## FREEPORT-MCMORAN

## Re: Permit No. GR002RE – Revision 14-1, Errata

Freeport-McMoRan Cobre Mining Company (Cobre) submitted an application to revise the referenced mining permit with a letter dated August 22, 2014. The application requests an increase in the permit boundary and design limits in order to facilitate the construction of a haul road between Cobre and Freeport-McMoRan Chino Mines Company.

FIGURE 3 PROPOSED MMD BOUNDARY WITH BLM PARCELS **APPLICATION FOR GR002RE**

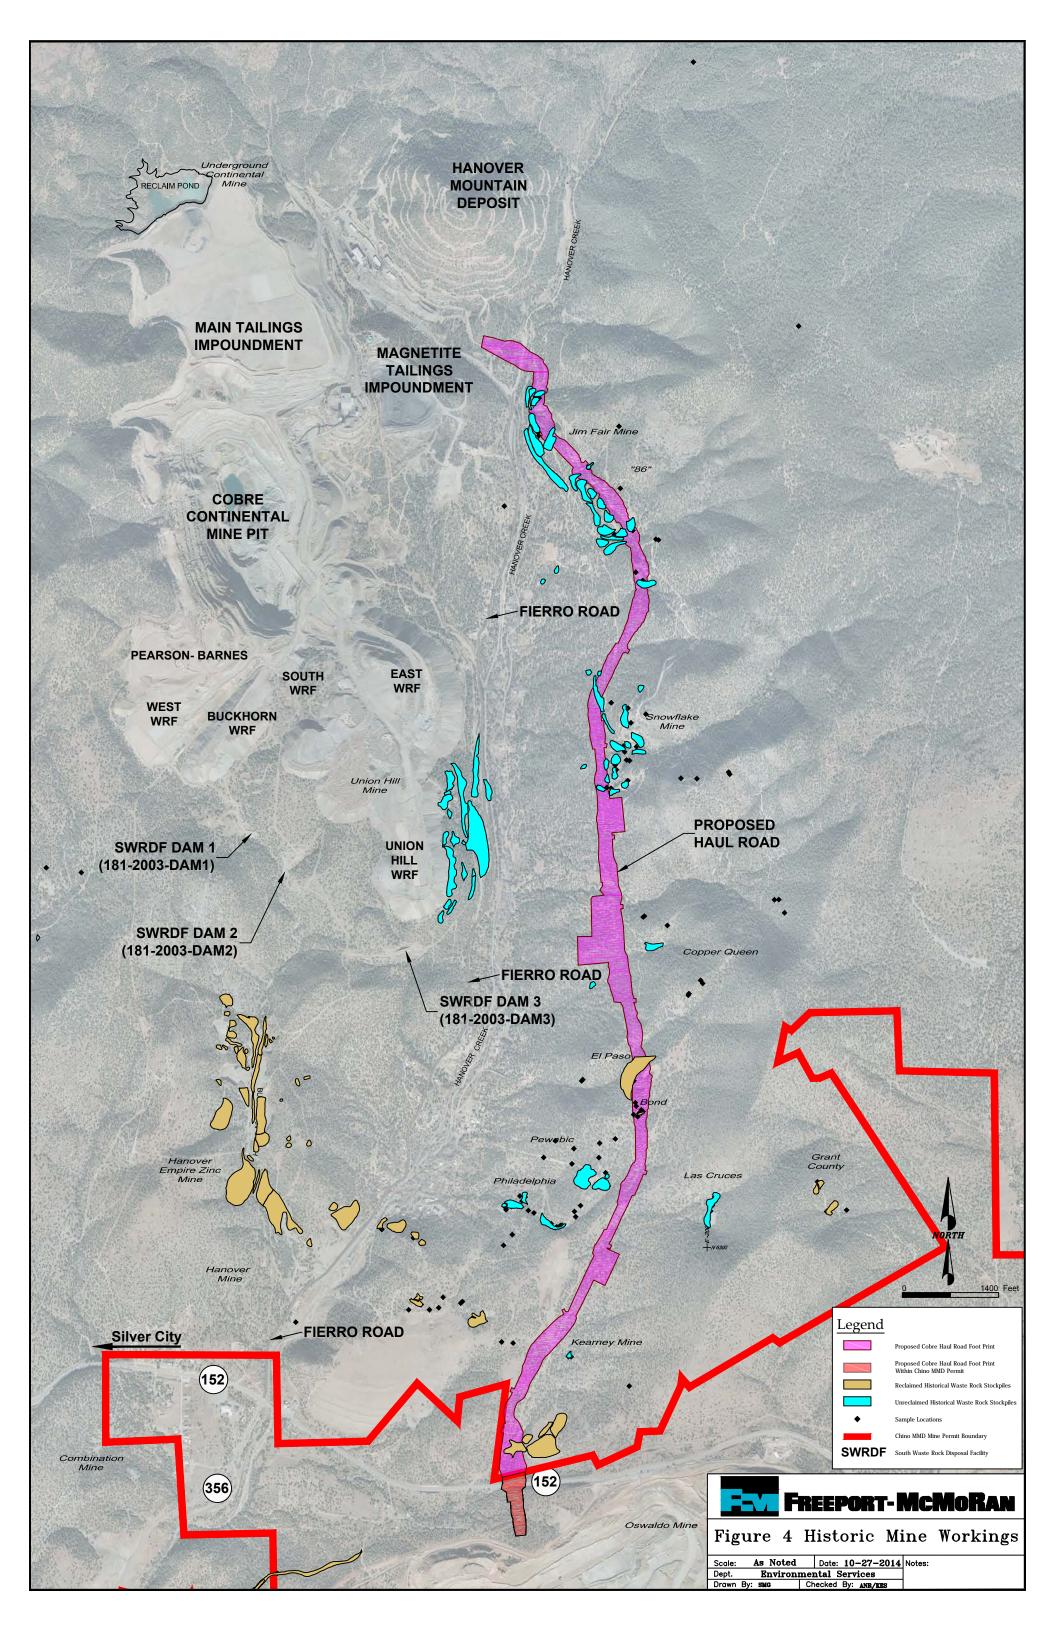
During an internal review of the application as submitted, Cobre discovered that the shape of the haul road on Figures 1-4 of the application and Figures A1, A3, A5, A6 and A9 of the closeout plan attached to the application is slightly incorrect. The actual shape is 2.7 acres less. The acreage descriptions in the application and the closeout plan <u>are</u> correct.
